## **ADDENDUM 1 – BID PACKAGE 2 PHASE B, C, D**

**DATE:** January 7, 2022 **M2 PROJECT #:** 201001

**PROJECT:** Greater Peoria Mass Transit

**OWNER:** GPMTD/ Citylink  
2105 N E Jefferson Ave, Peoria, IL

COMMUNICATIONS &  
SPECIAL SYSTEMS  
ENLARGED PLANS

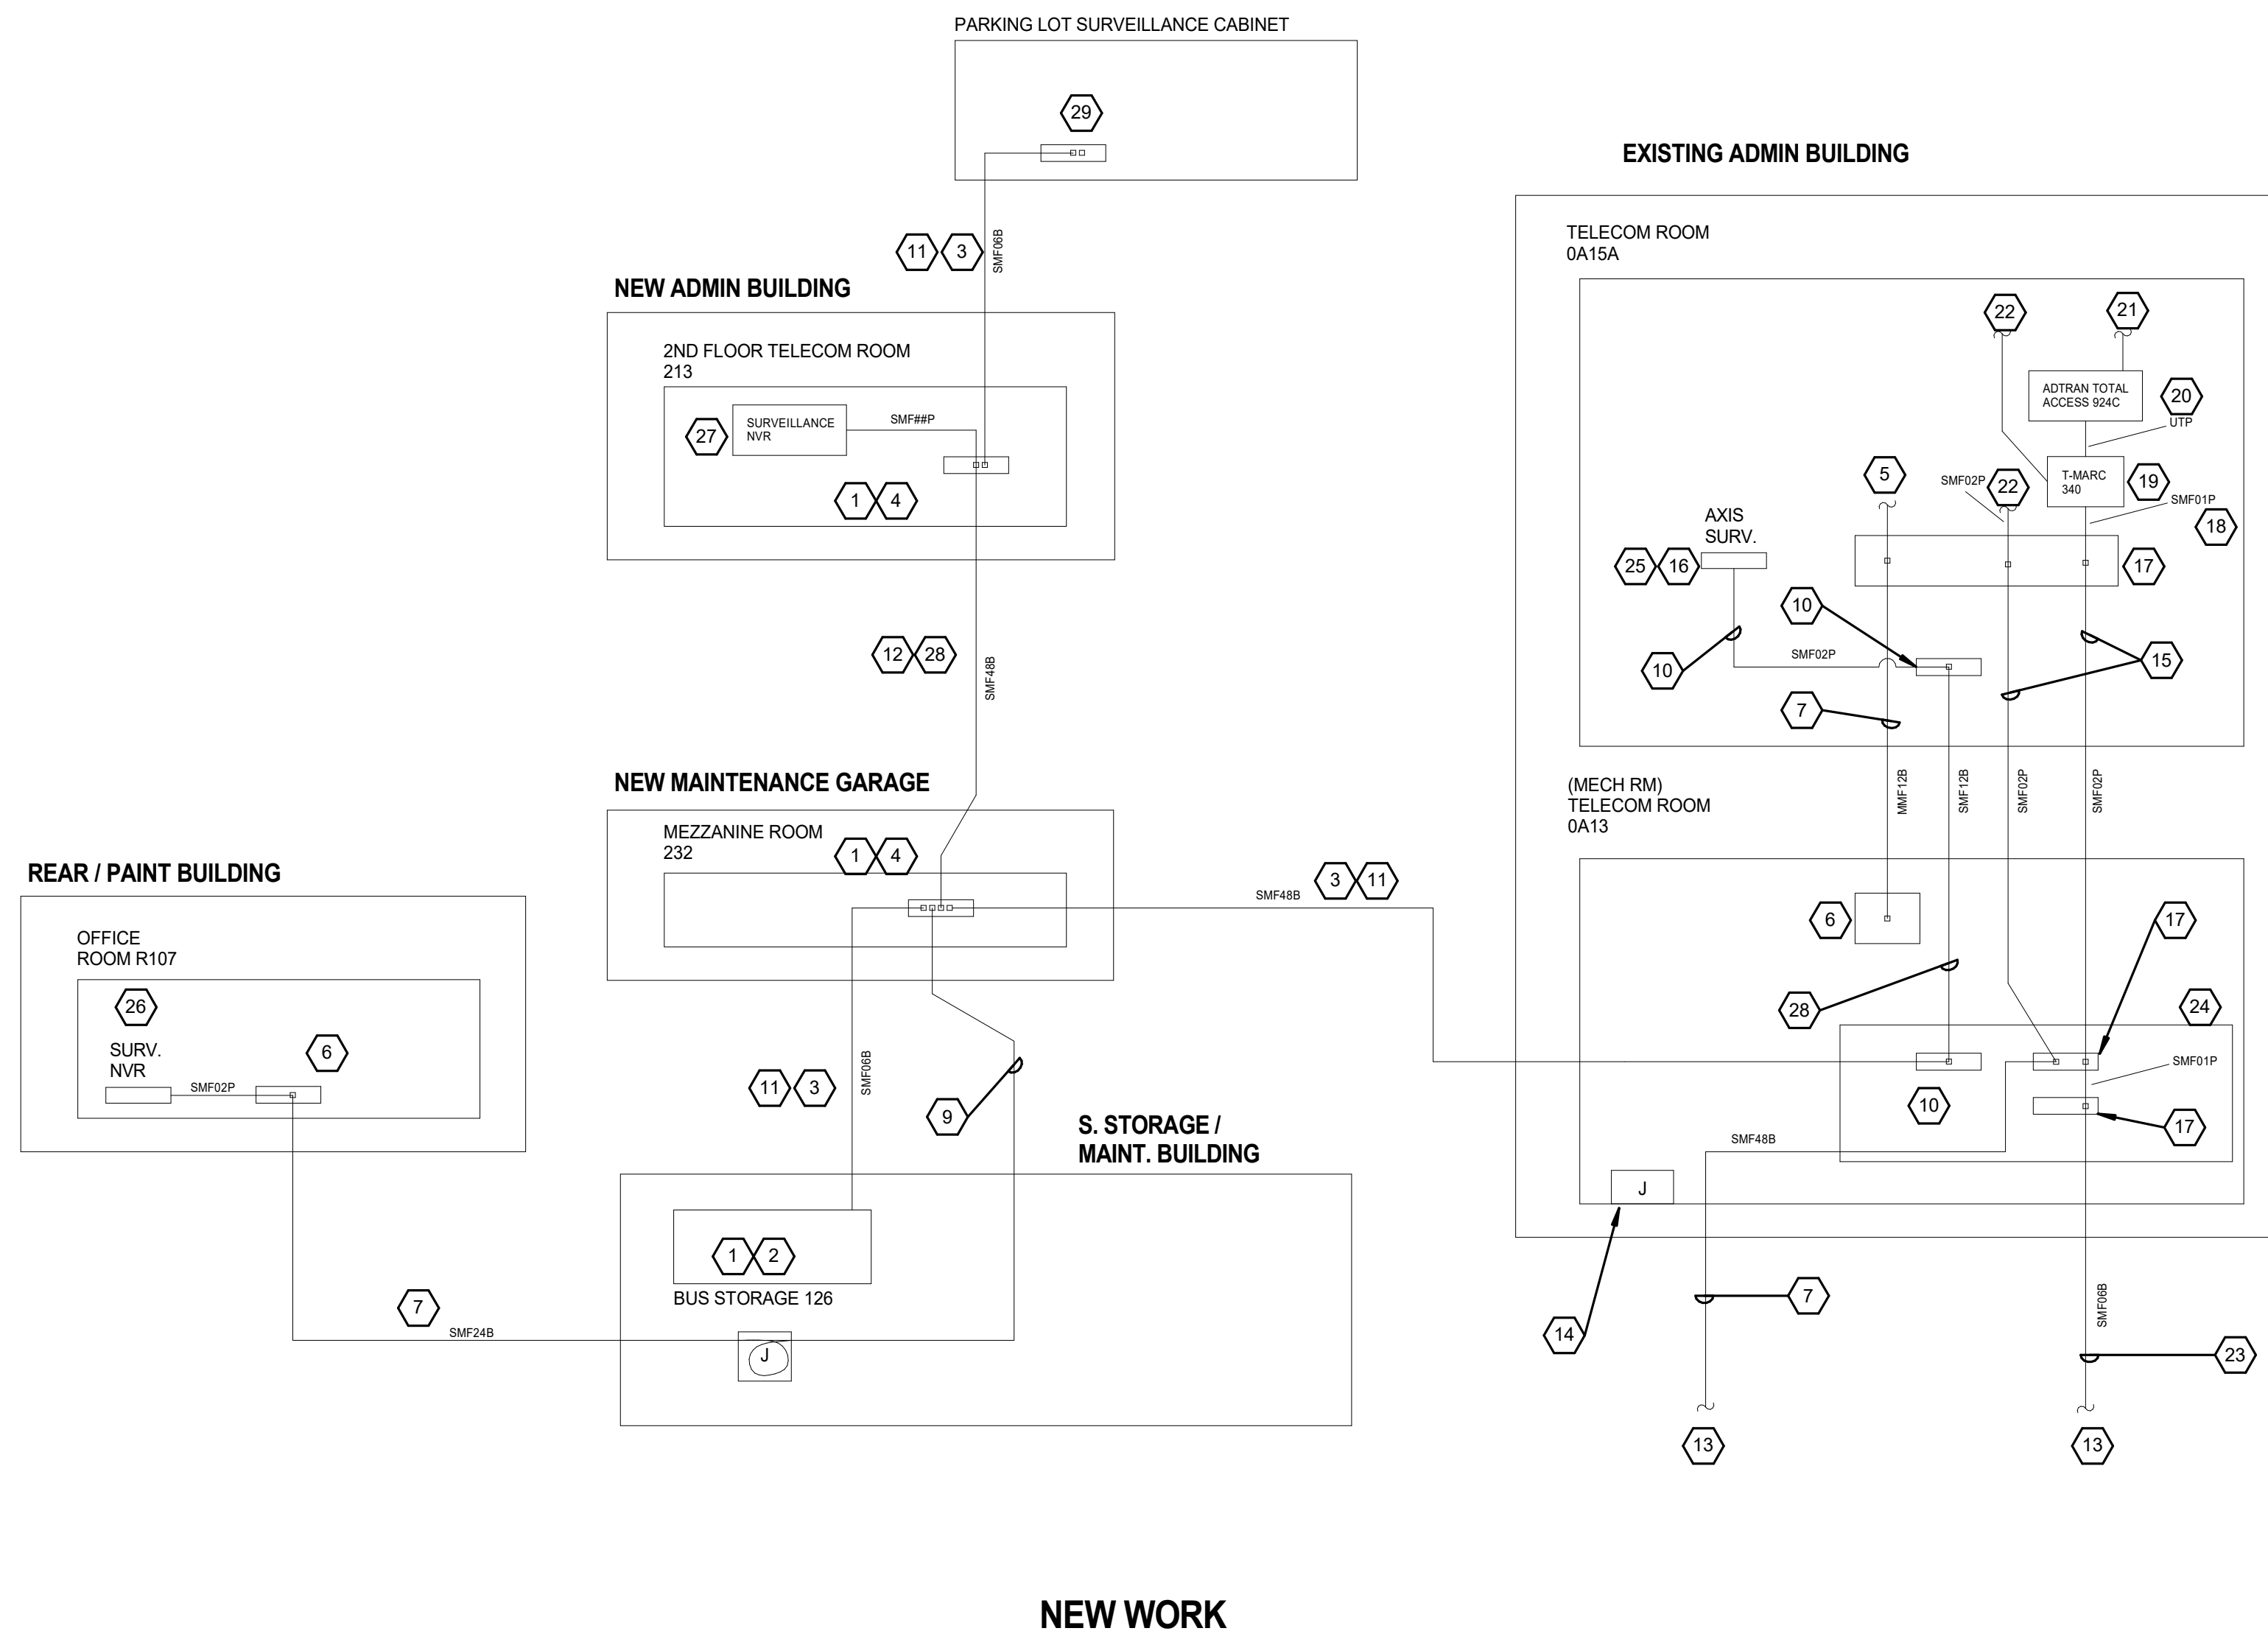
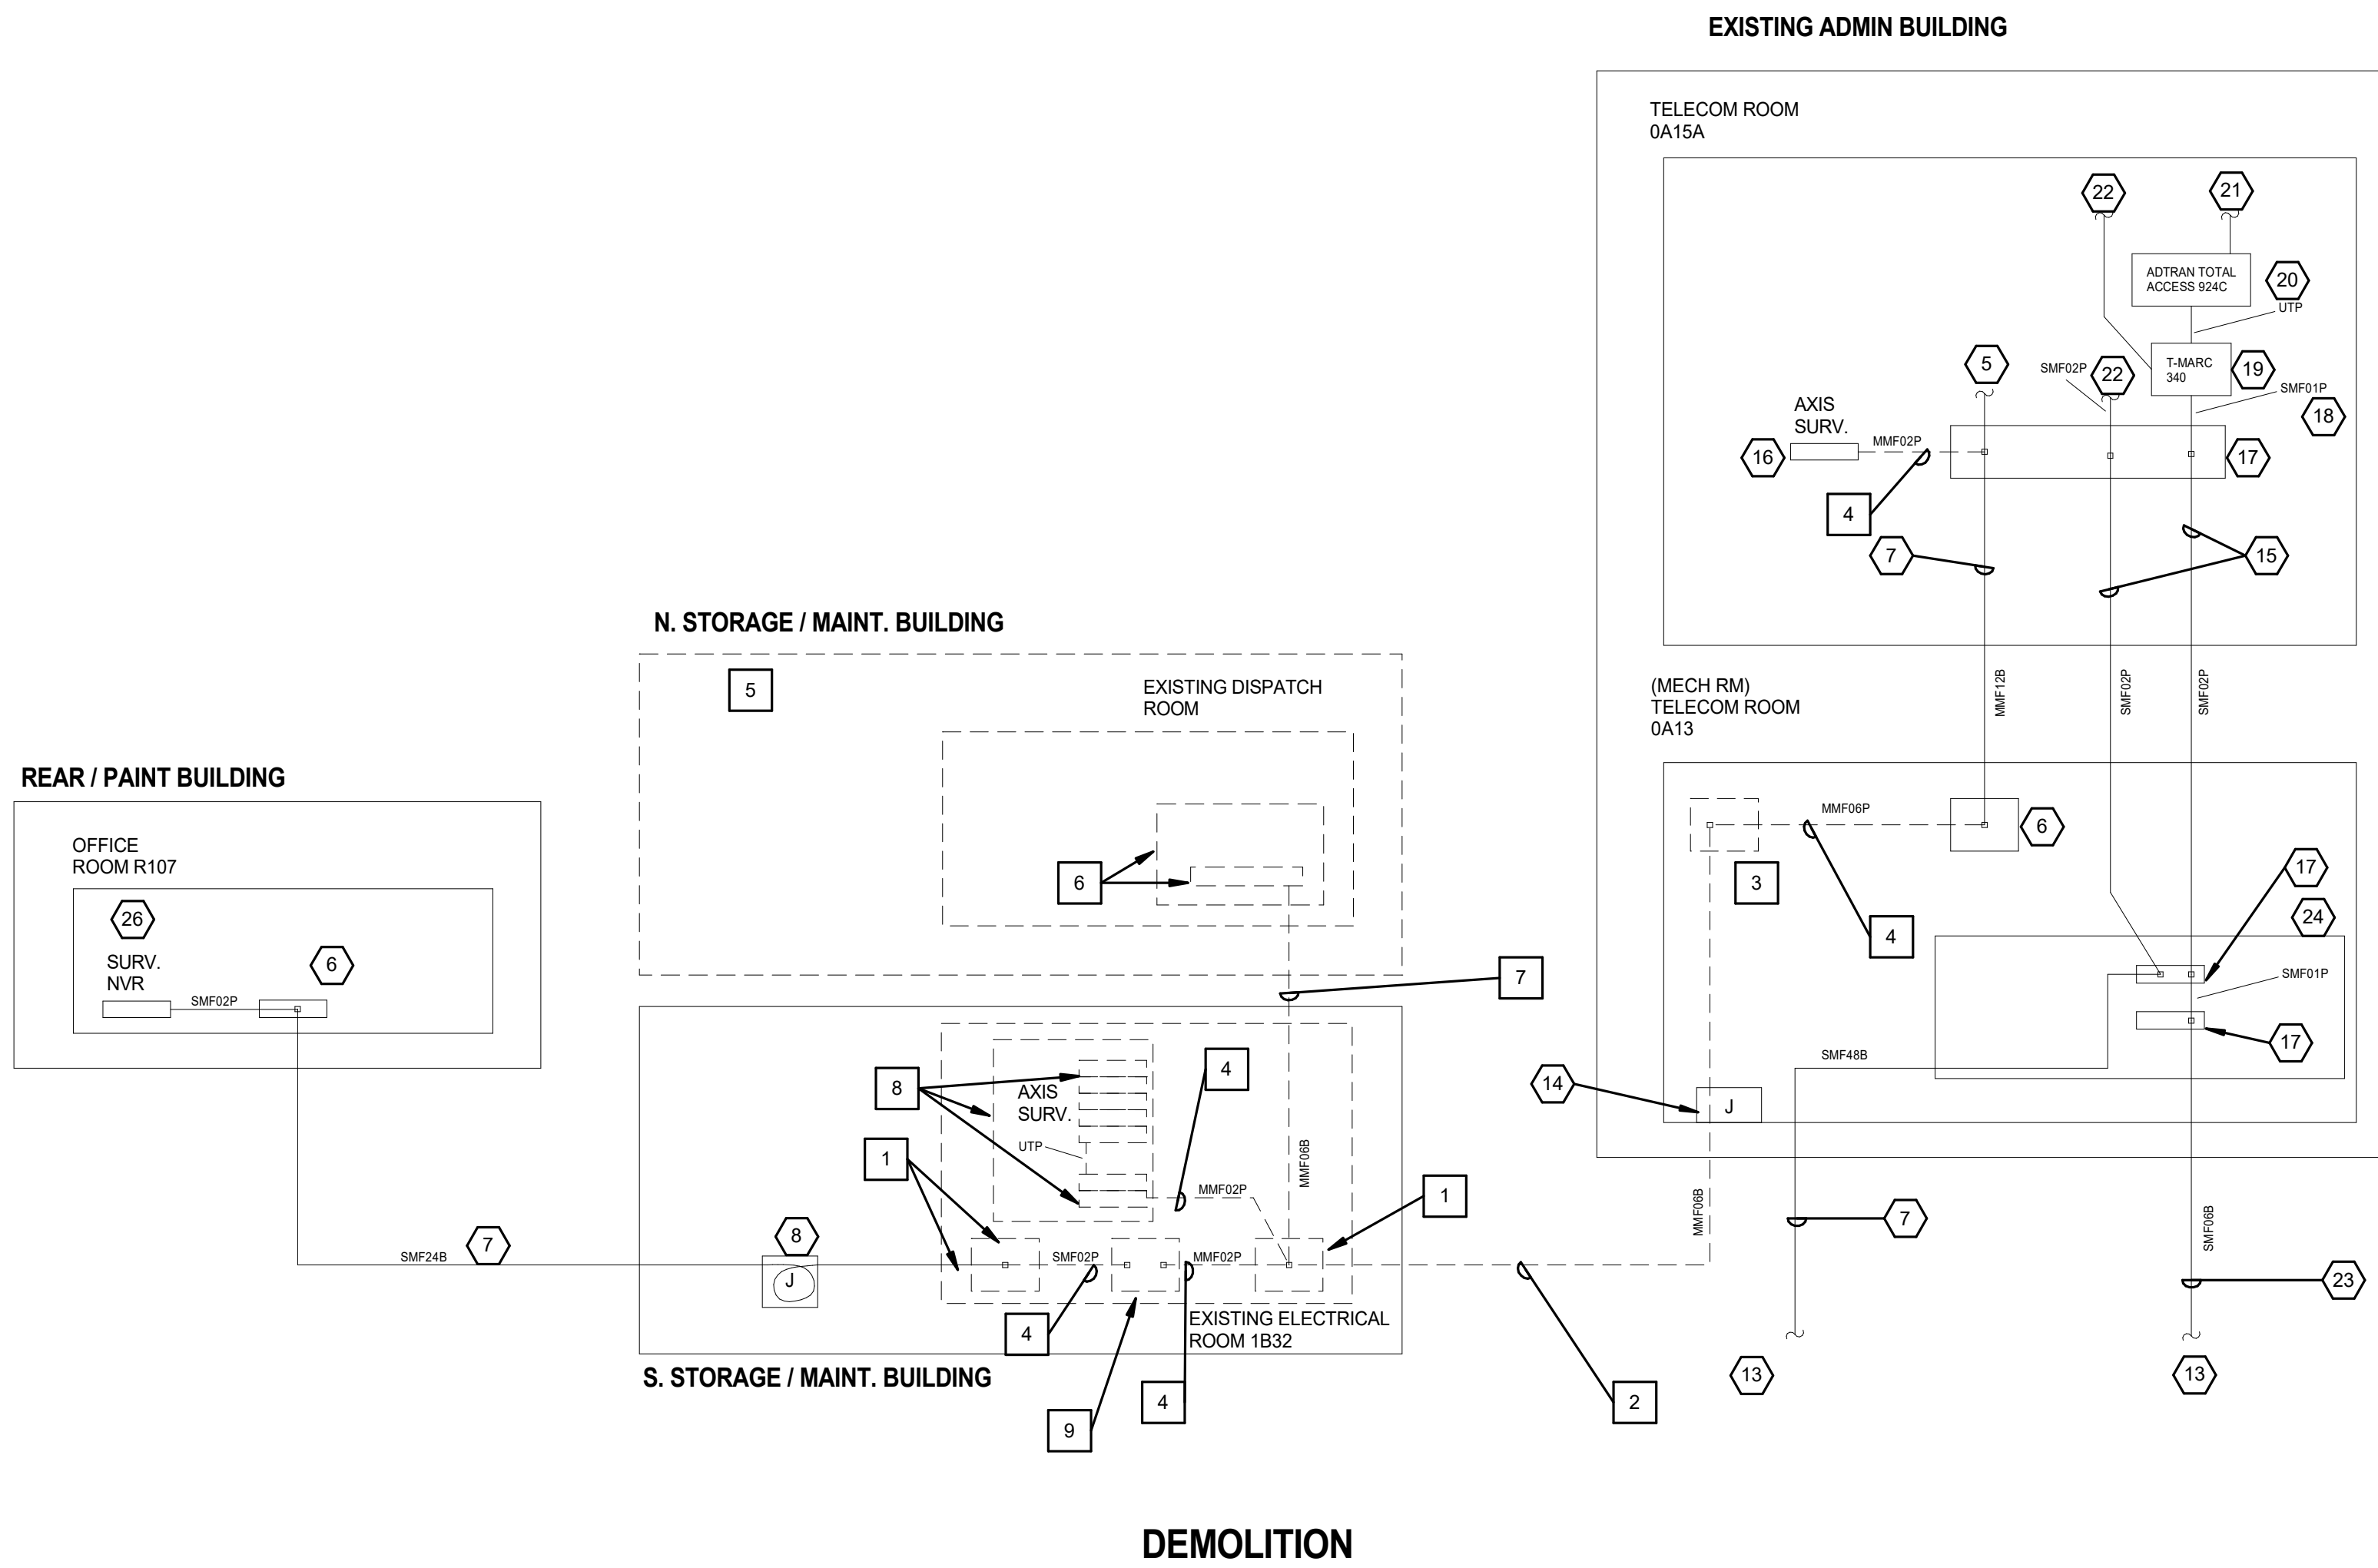
Updated details 1,2,3,4, and 5. Room 213 was changed and made larger from bid drawings. Room layouts and rack elevations have been updated to reflect new equipment specifications.

Added keynotes 42-50.

Updated keynotes 1 and 14. Contractor now provides network switches, updated equipment cabinet keynote (previously specified a standard relay-type rack).

COM-401

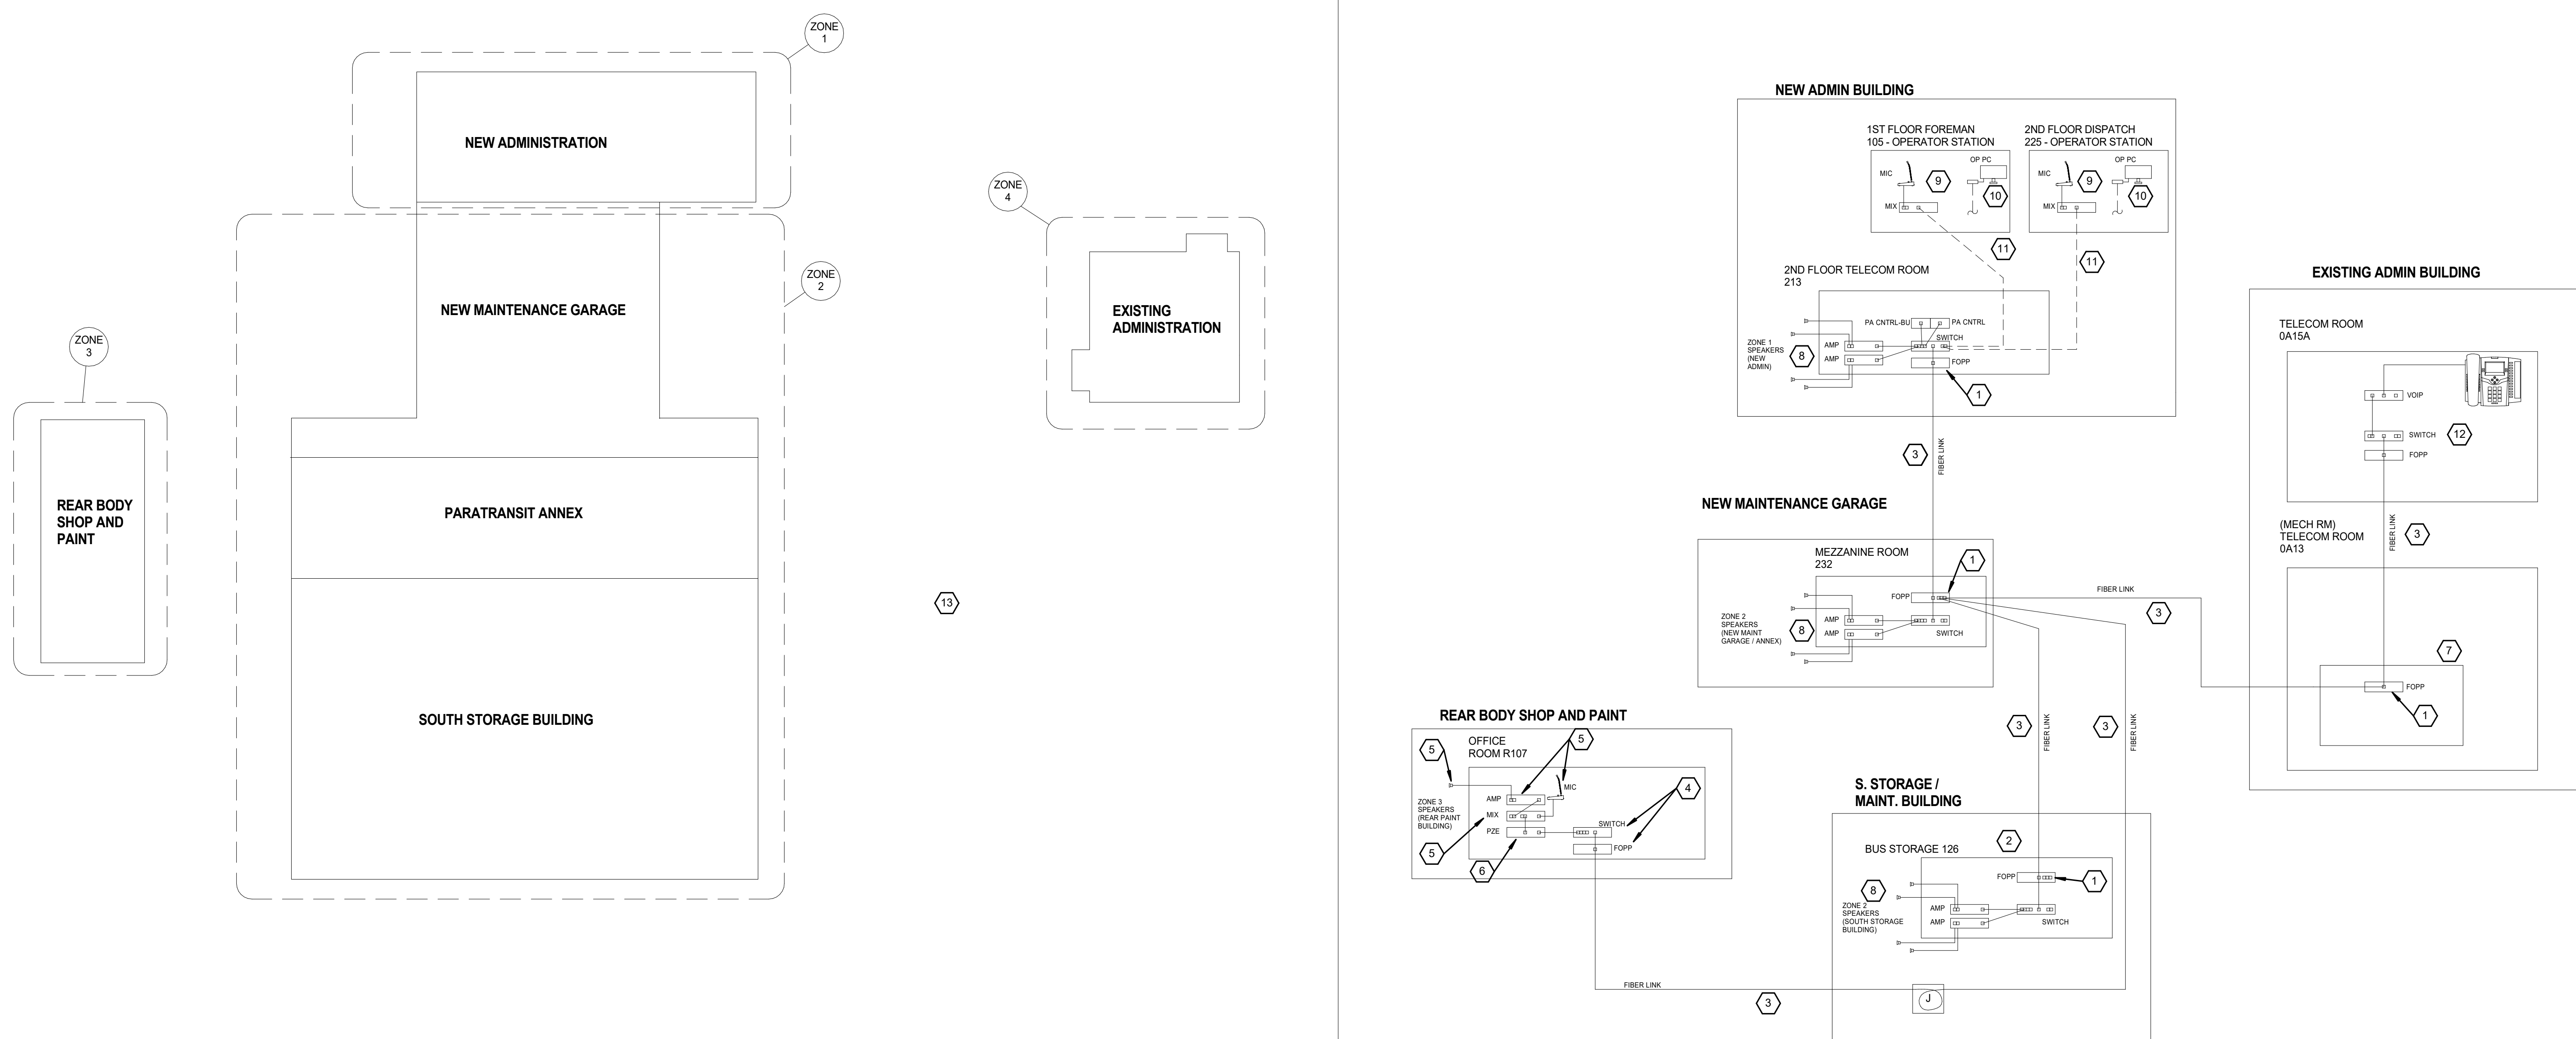
Updated general note 11 to reflect that contractor provides network switches.
